**PROPOSED SOCIAL WELFARE FACILITY (RESIDENTIAL CARE HOME FOR THE ELDERLY) IN  
“VILLAGE TYPE DEVELOPMENT” ZONE ON APPROVED NAM SANG WAI OUTLINE ZONING  
PLAN NO. S/YL-NSW/10 AT LOTS 3670 RP (PART), 3671 RP (PART), 3672 RP (PART) AND 3673  
RP (PART) IN D.D.104, NAM SANG WAI, YUEN LONG**

**Town Planning Application No. A/YL-NSW/349 - Submission of Further Information (6)**

**Response-to-Comment Table**

Figure No. 2.7 Revision C

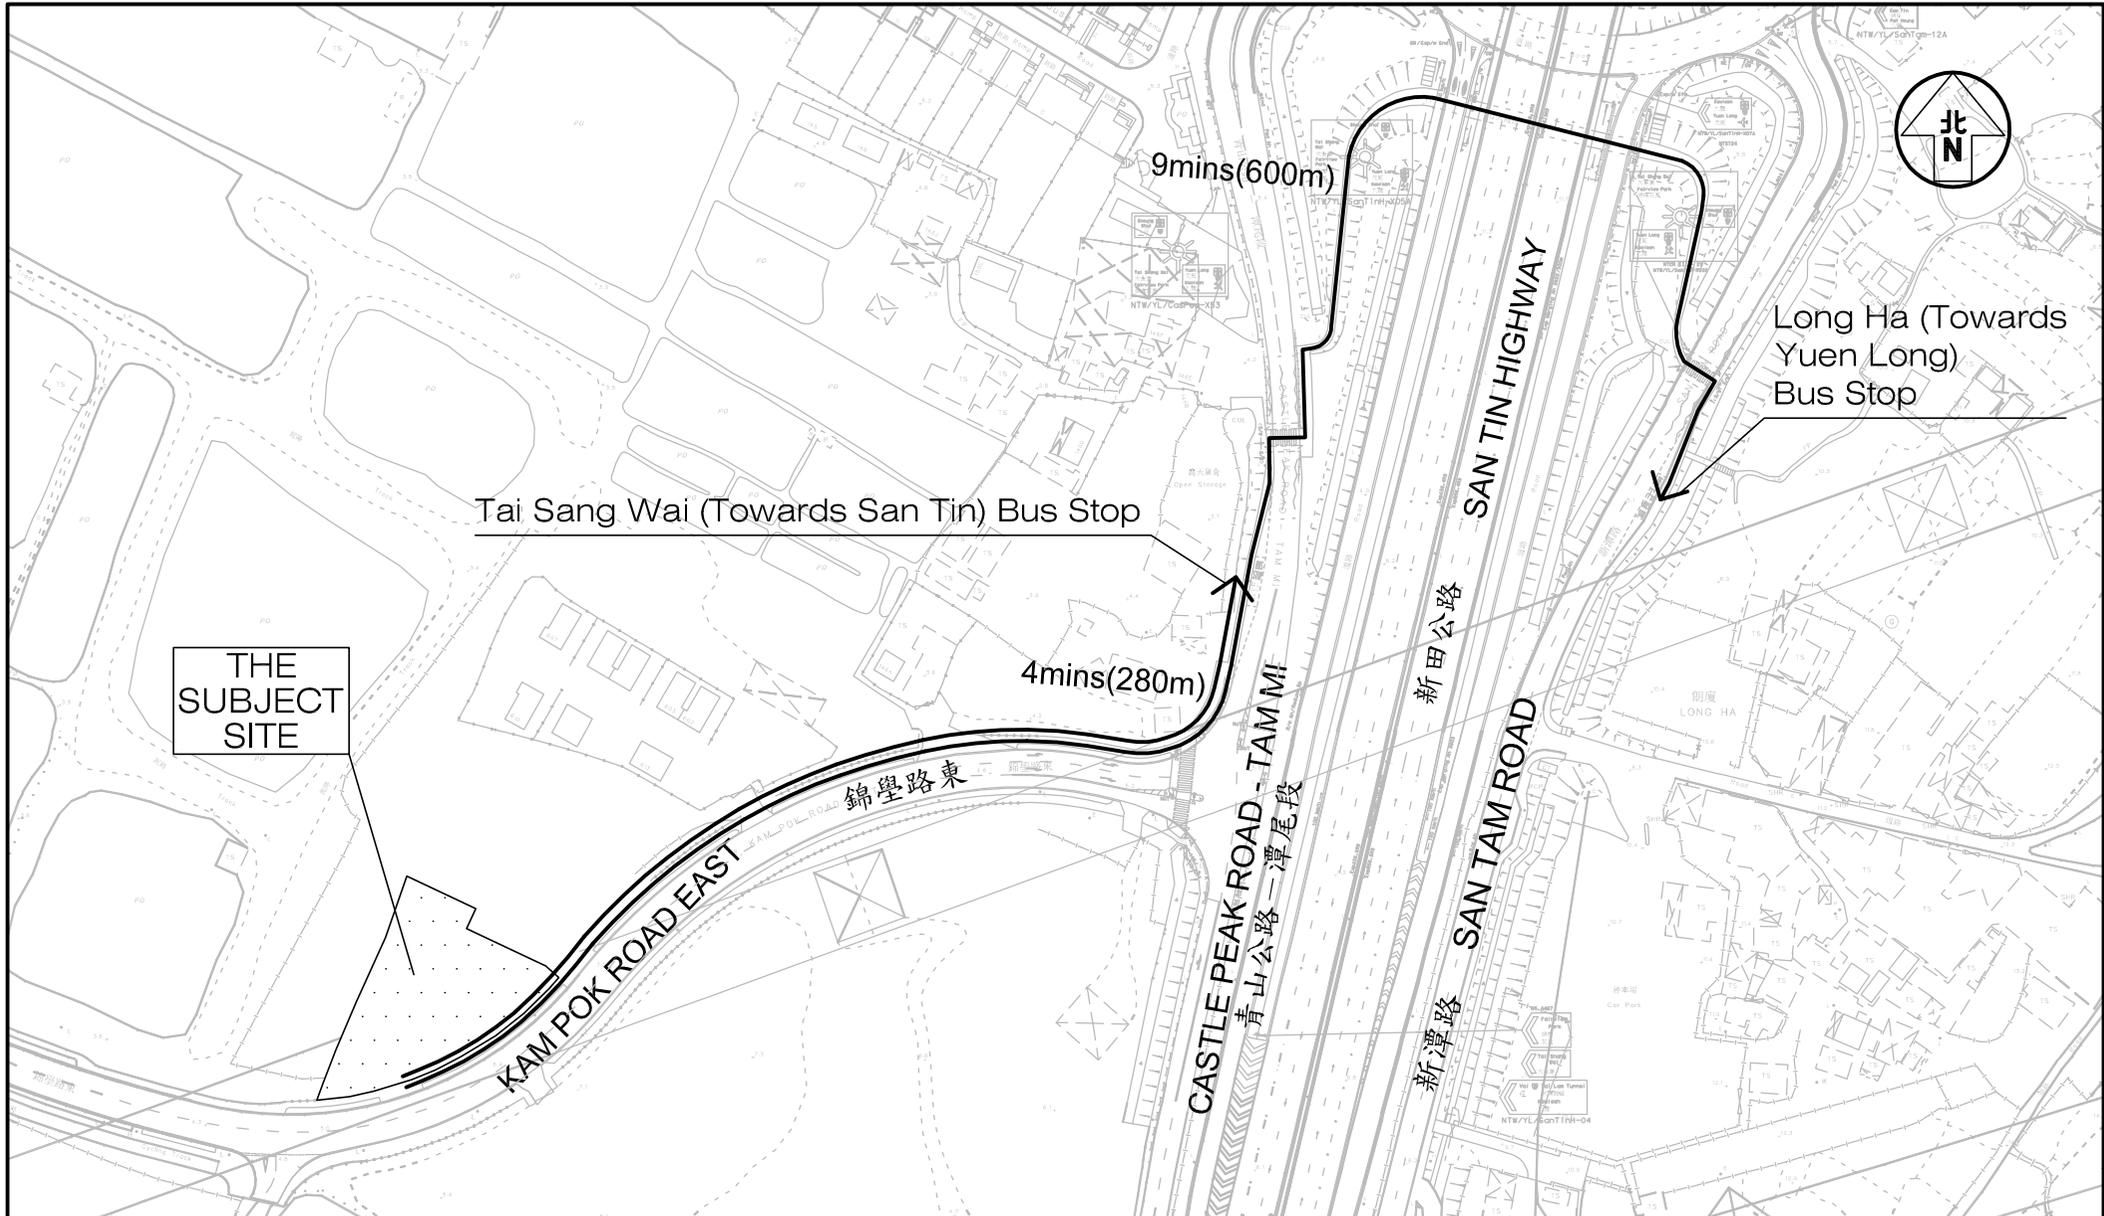
12. Please provide a plan showing the pedestrian routing to the nearby franchised bus stop (both Yuen Long and Sheung Shui bound). Please specify the corresponding walking distance as well;	Noted. Please refer to Figure 2.7 in the revised TIA for the pedestrian route to the nearby franchised bus stops.

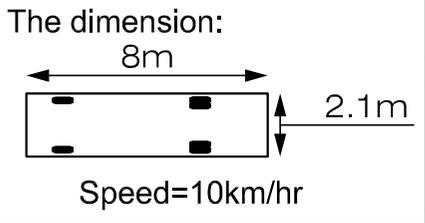
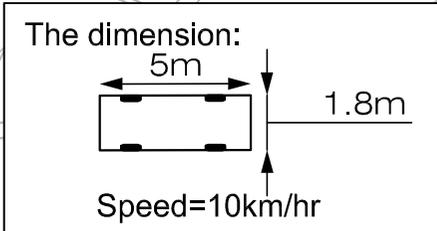
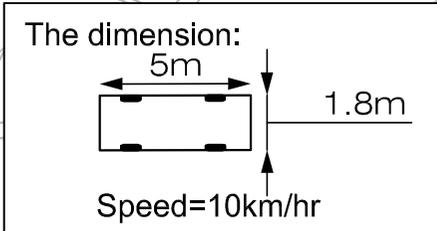
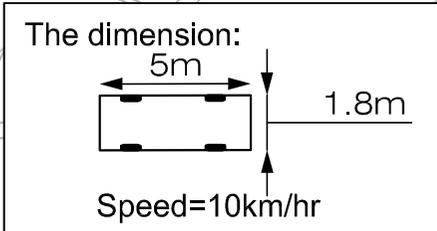
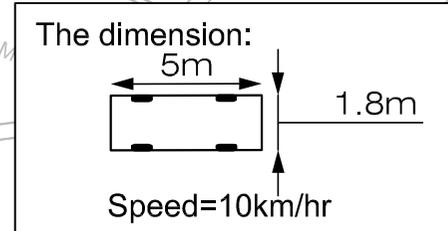
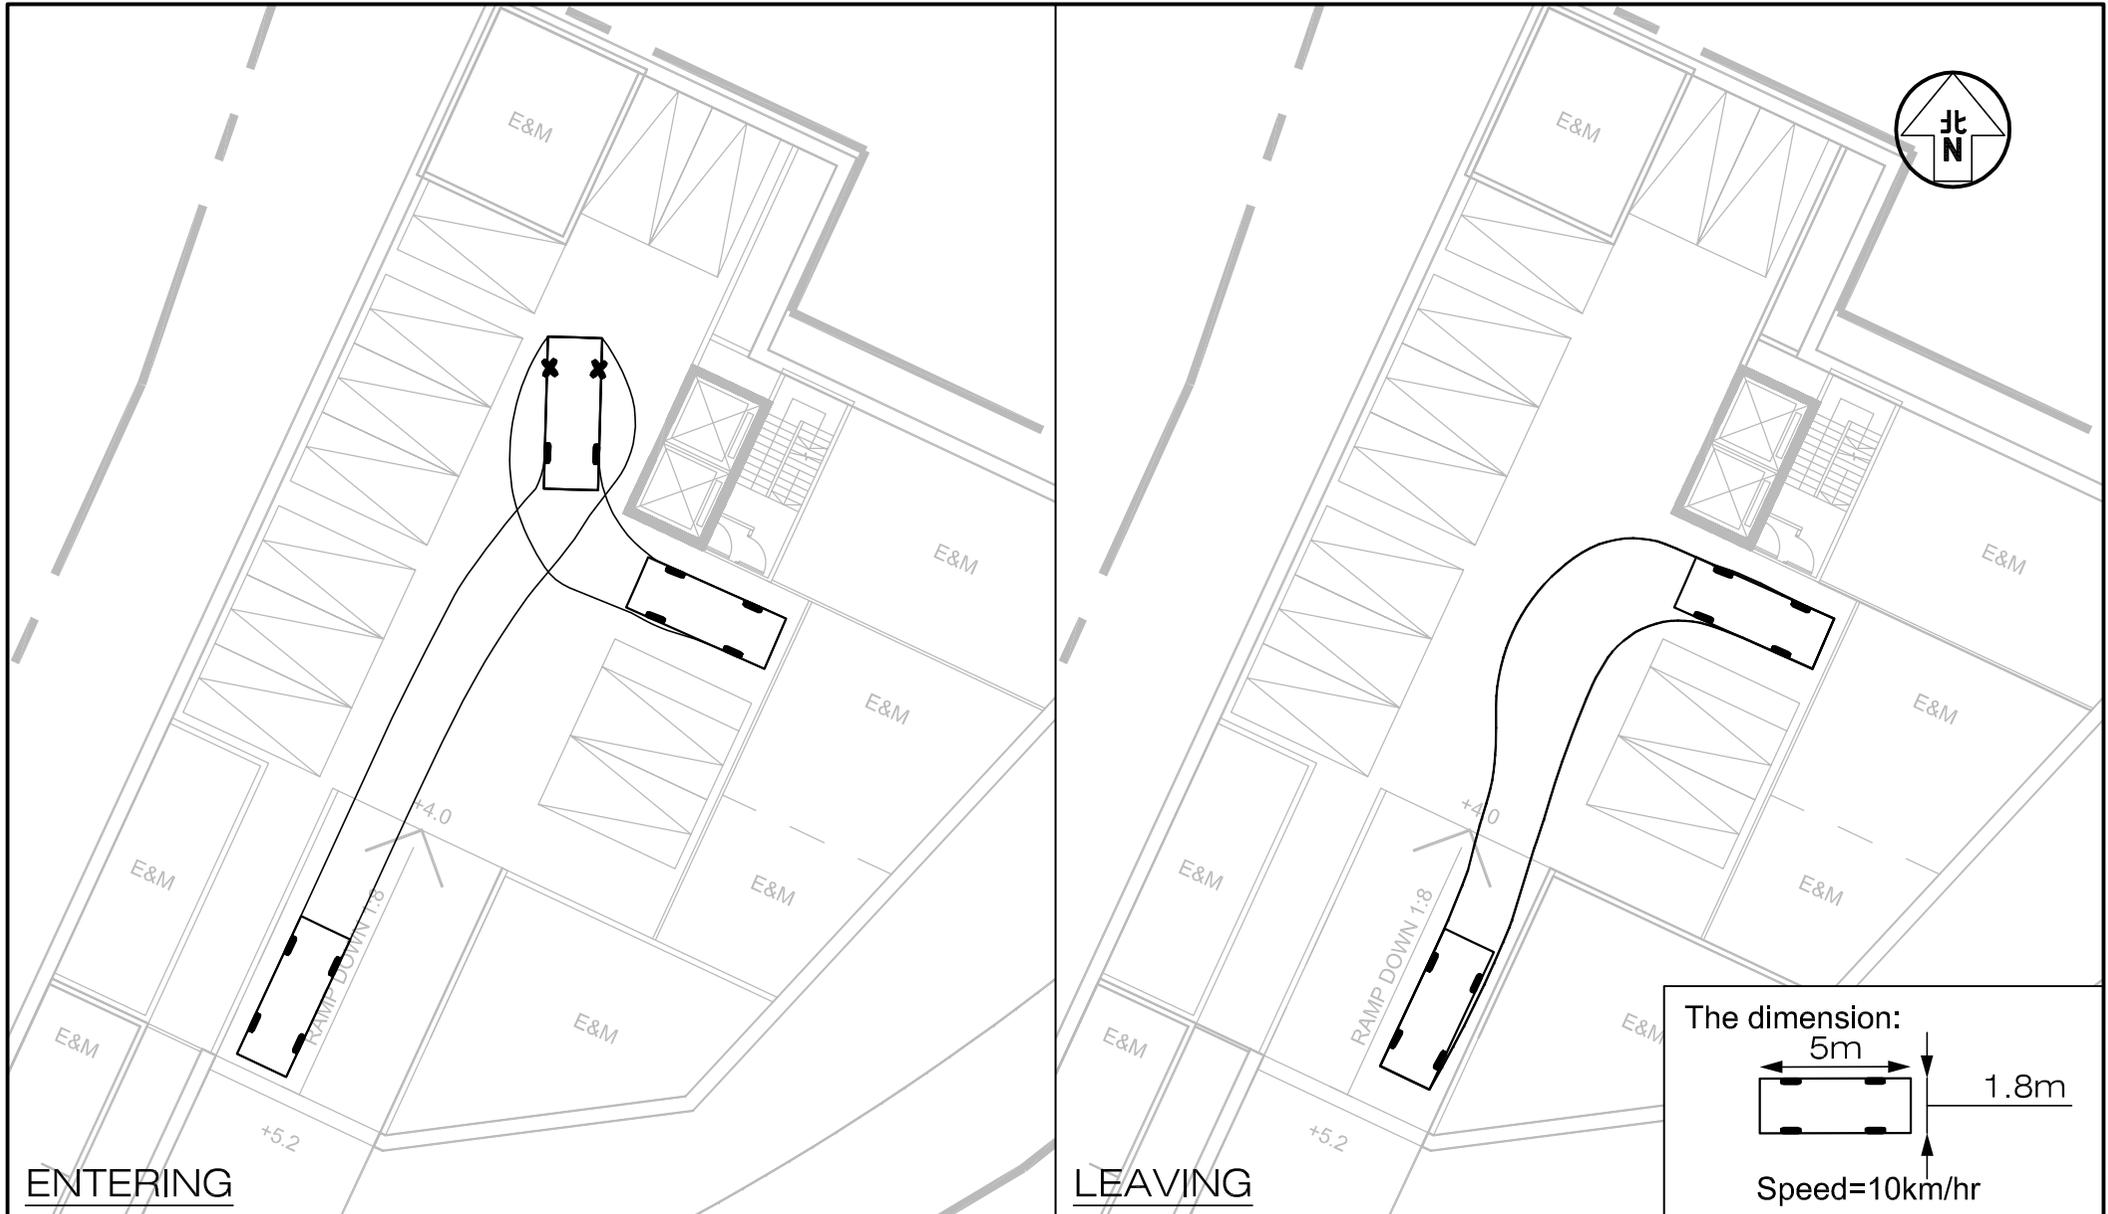
2.	Given the congested area at the site entrance, the management staff should be on-site at all time to manage the traffic.	Noted.
3.	Re. RtC Item 6: It appears that your checking of visibility splay has not taken into account of the existing planter. Please revisit the checking and demonstrate sufficient sightline could be maintained at all time since the commissioning of RCHE.	In order to ensure the adequate sightline for vehicles and pedestrian, the amendment of existing planter is needed to ensure no obstructions taller than 1.05m will be erected within the visibility splay at the run-in/out.

**FIGURE 3**  
**PROPOSED TERMINAL MANHOLE AND**  
**CONNECTION**

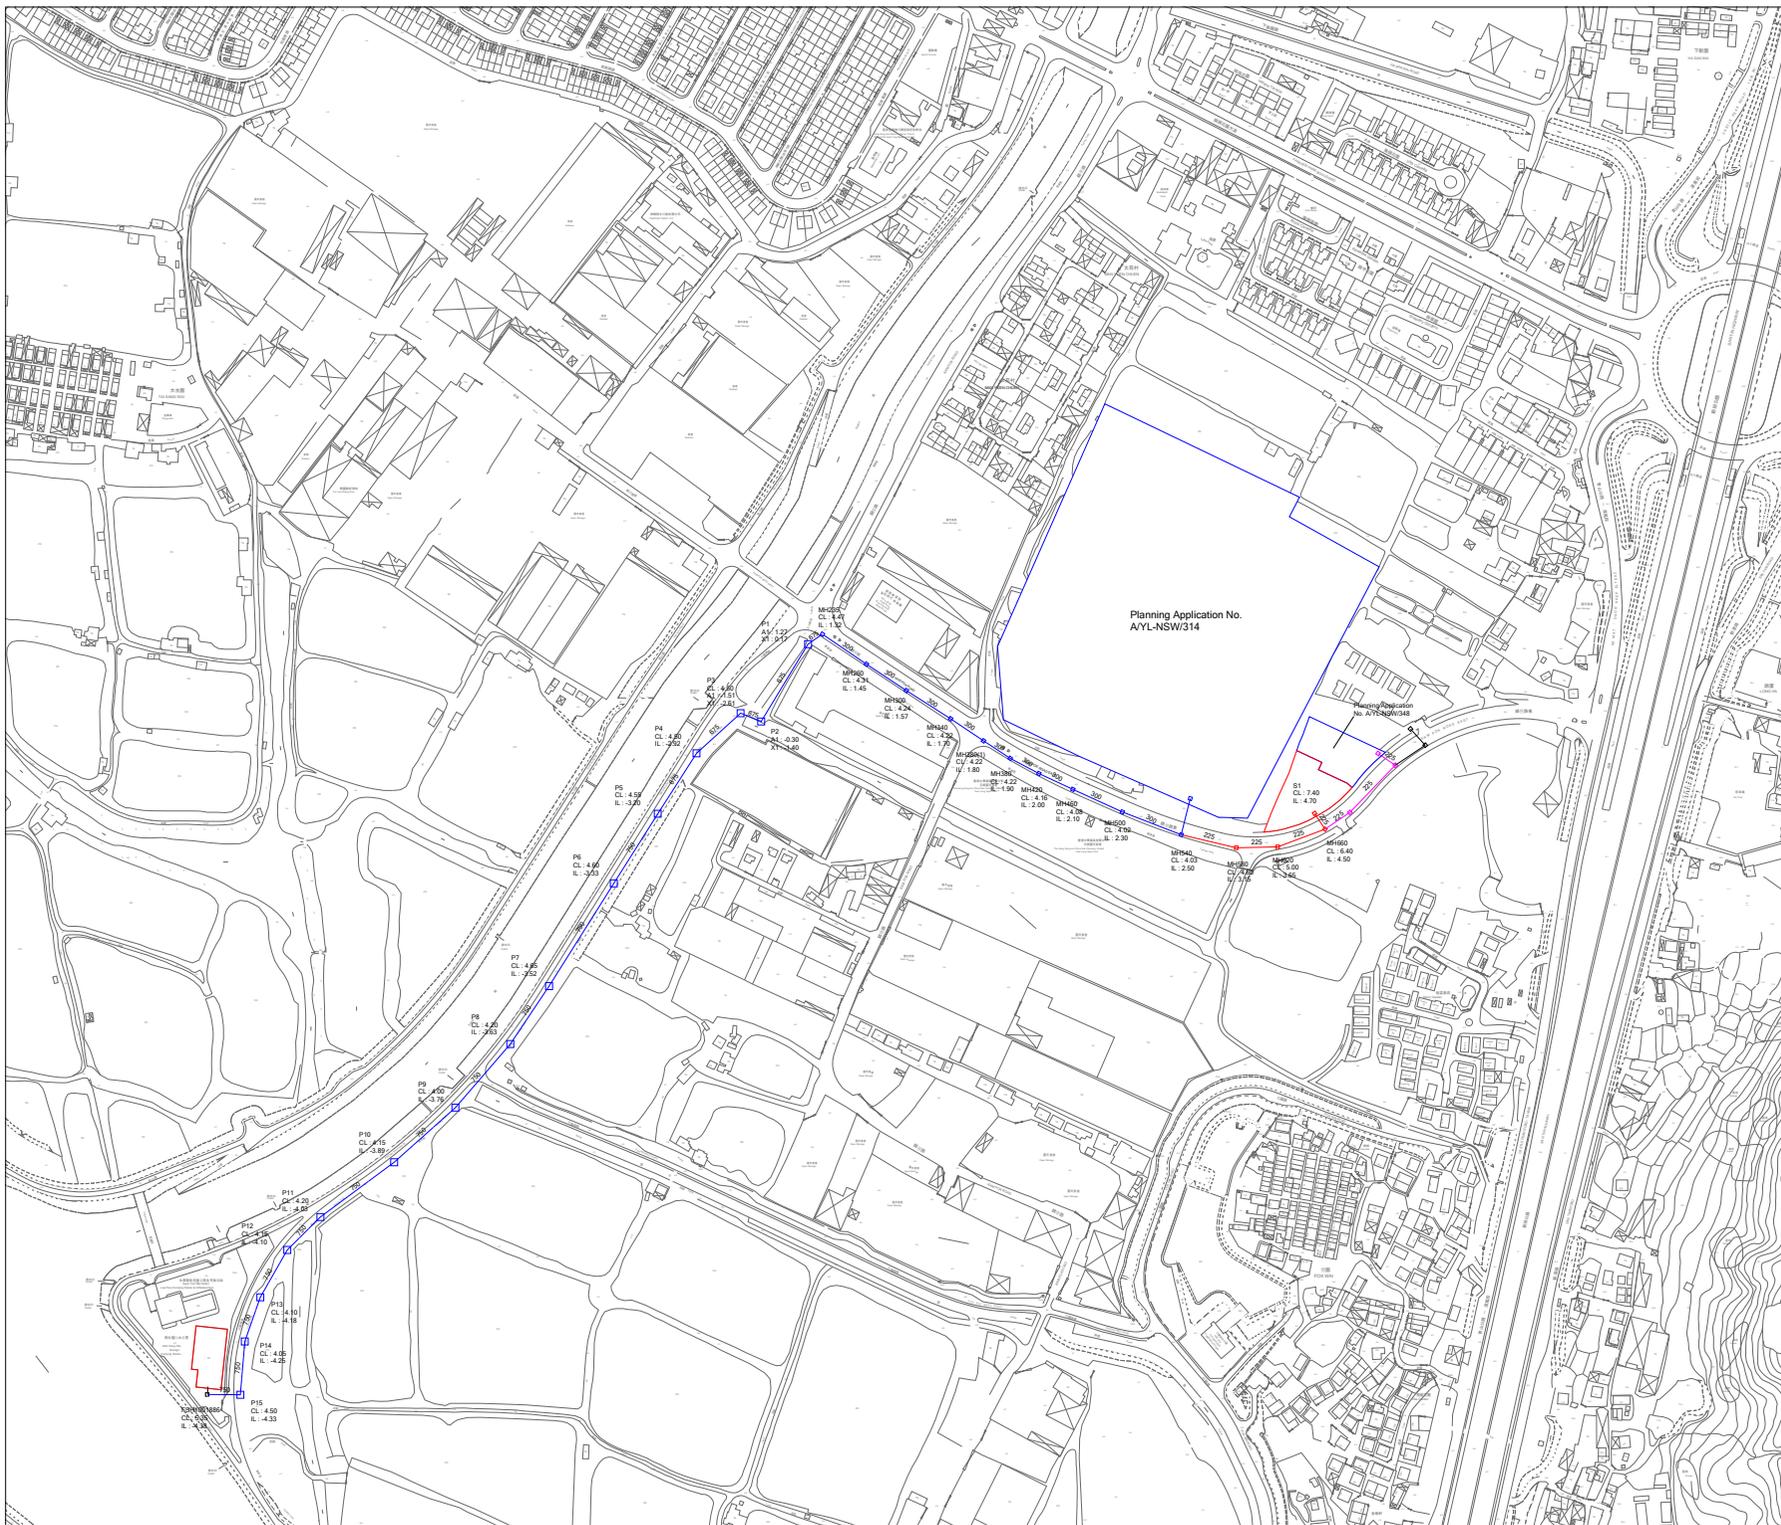
2.	RtC item 3, Section 2.3.2 & Section 2.4.2 & Appendix B– Please confirm and state if the planned sewers mentioned under Section 2.4.2 means proposed sewers P1 to P15 and upgraded sewer MH540 to MH235 under planning application No. A/YL-NSW/314, and if other sewers as proposed by other planning applications mentioned under Section 2.3.2 are not proposed to be utilised by the proposed development under this SIA. If this is the case, a hydraulic assessment adopting proposed sewers P1 to P15 and upgraded sewer MH540 to MH235 under planning application No. A/YL-NSW/314 would serve the purpose and the last two sentences of Section 2.3.2 should be deleted. If not, please consider different sewage disposal scenarios the SIA including hydraulic assessment.	It is confirmed that planned sewers mentioned under Section 2.4.2 means proposed sewers P1 to P15 and upgraded sewer MH540 to MH235 under planning application No. A/YL-NSW/314. The last two sentences of Section 2.3.2 had been deleted.

3.	Section 2.4.2 – Please revise the second sentence as “In case these planned sewers i.e. proposed sewers between MH235 to FSH1001886 and upgraded sewers between MH540 to MH235 under planning application No. A/YL-NSW/314 are not available...”.	Revised.
